SUNDRY NOTICES AND REPORTS ON WELLS (DO NOT USE THIS FORM FOR PROPOSALS TO DRILL OR TO DEEPEN OR PLUG BACK TO A DIFFERENT RESERVOIR. USE "APPLICATION FOR PERMIT" (FORM C-101) FOR SUCH PROPOSALS.)		WELL API NO. 30-025-48505

2. Name of Operator Devon Energy Production Co. LP		6. State Oil & Gas Lease No.
3. Address of Operator 333 W. Sheridan Ave OKC, OK 73102		7. Lease Name or Unit Agreement Name PARSELTONGUE 15 10 STATE COM

Parseltongue 15-10 State Com 22H

Operator: DEVON ENERGY PRODUCTION COMPANY, LP 333 West Sheridan Ave. Oklahoma City, OK 73102	OGRID: 6137
	Action Number: 112733
	Action Type: [C-103] NOI Change of Plans (C-103A)

qcactus
Wellhead2-9-17
E Bell

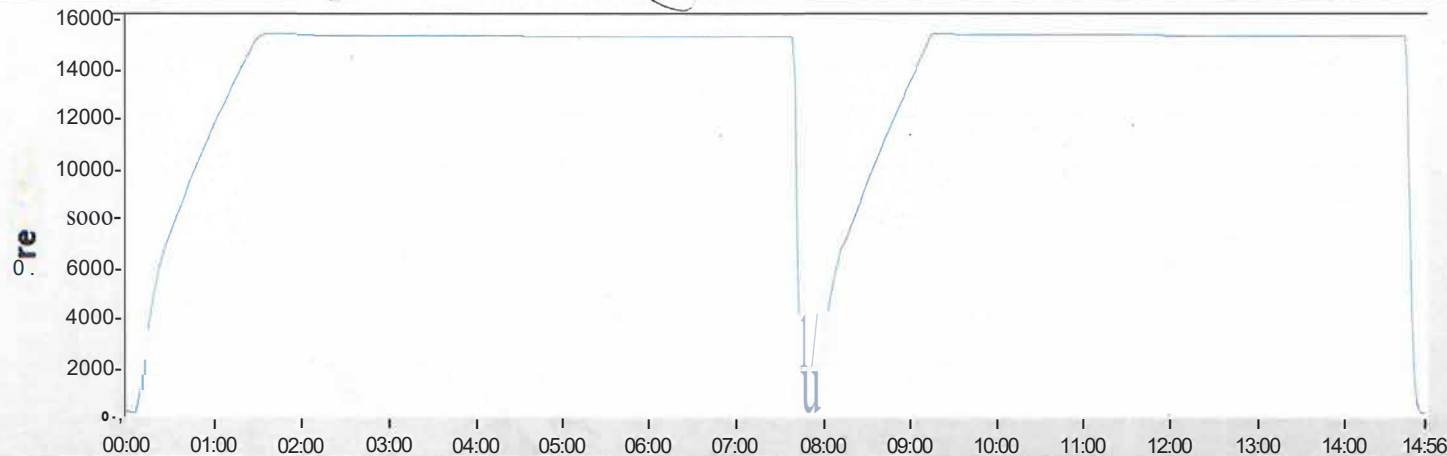
Devon Energy respectfully requests approval for optional surface casing/drilling plan of 10-3/4" surface casing inside of 13-1/2" surface hole at previously permitted set depth. Devon Energy Production Company, LP. will circulate class C cement to surface behind the 10-3/4" casing. Please see revised drill plan. Devon is also requesting a break test variance. The variance request and chart are attached.

Devon Energy requests to only test BOP connection breaks after drilling out of surface casing and while skidding between wells which conforms to API Standard 53 and industry standards. This test will include the Top Pipe Rams, HCR, Kill Line Check Valve, QDC (quick disconnect to wellhead) and Shell of the 10M BOPE to 5M for 10 minutes. If a break to the flex hose that runs to the choke manifold is required due to repositioning from a skid, the HCR will remain open during the shell test to include that additional break. The variance only pertains to intermediate hole-sections and no deeper than the Bone Springs Formation where 5M BOP tests are required. The initial BOP test will follow OOGO2.III.A.2.i, and subsequent tests following a skid will only test connections that are broken. The annular preventer will be tested to 100% working pressure. This variance will meet or exceed OOGO2.III.A.2.i per the following: Devon Energy will perform a full BOP test per OOGO2.III.A.2.i before drilling out of the intermediate casing string(s) and starting the production hole, before starting any hole section that requires a 10M test, before the expiration of the allotted 14-days for 5M intermediate batch drilling or when the drilling rig is fully mobilized to a new well pad, whichever is sooner. We will utilize a 200' TVD tolerance between intermediate shoes as the cutoff for a full BOP test. The BLM will be contacted 4hrs prior to a BOPE test. The BLM will be notified if and when a well control event is encountered. Break test will be a 14 day interval and not a 30 day full BOPE test interval. If in the event break testing is not utilized, then a full BOPE test would be conducted.
